Docket Item # 12 BAR CASE # 2009-0121

BAR Meeting July 8, 2009

ISSUE:	Alterations
APPLICANT:	Wilson Grand, LLC
LOCATION:	429 N. St. Asaph Street
ZONE:	RM/Residential

Figure 5: Detail View of Proposed Fence/Screen

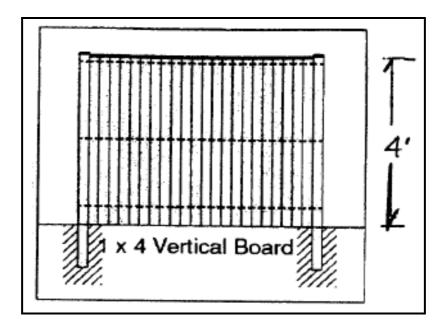
Staff supports the applicant's request for the installation of a replacement emergency generator, with the recommendation that the design of the screening be altered to be more open, possibly utilizing a horizontal/vertical lattice for the screen. Additionally, the height of the screening should be reduced to only three feet (3') tall, which is one foot (1') higher than the height of the proposed generator. Finally, to ensure that the screening will complement the surrounding built environment, Staff recommends the screen be painted or stained.

1. That the design of the screening will be altered to be more visually open and the height of the screening will be reduced to three feet (3') high, which is one foot (1') higher than the height of the proposed generator.

2. That the wood screen will be painted or stained.

Figure 6: Sketch of Proposed Location of Generator/Fence on Subject Property

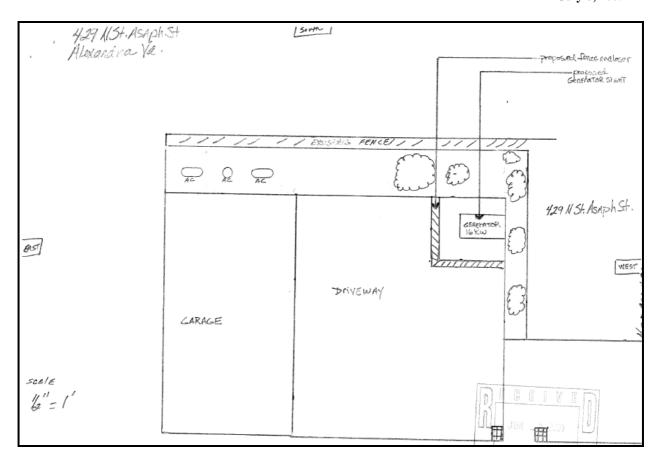
The applicant is requesting approval of a Certificate of Appropriateness to install a replacement emergency generator (two feet (2') wide x four feet (4') long x two feet (2') high) surrounded by a four foot (4') high wood fence on the property at 429 North Saint Asaph Street.

The proposal complies with the RM requirements of the Zoning Ordinance and does not impact the subject property's open-space calculations as it is being sited on an existing impermeable surface – the current brick paver driveway.
